TECHNICAL BULLETIN

HAS TRUCK AIR SUSPENSIONS HEIGHT CONTROL VALVE IMPROVEMENT

No: TRUCK AUS -016
Subject: HCV Exhaust Port Filter
Date: JULY 2002 **Revision:** A

HCV EXHAUST

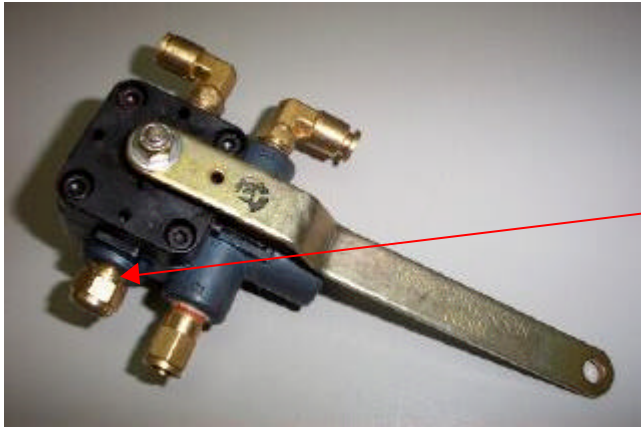
Hendrickson installation instructions indicate the fitment of 3/8" nylon tubing approximately 500mm long to the exhaust port of the valve.

This has now been replaced with a filter to prevent the ingress of contaminants.

This item is now standard fitment and is contained in all new kits as well as replacement Height Control Valves.

The non fitment of this item may allow dirt to enter and cause premature failure of the HCV.
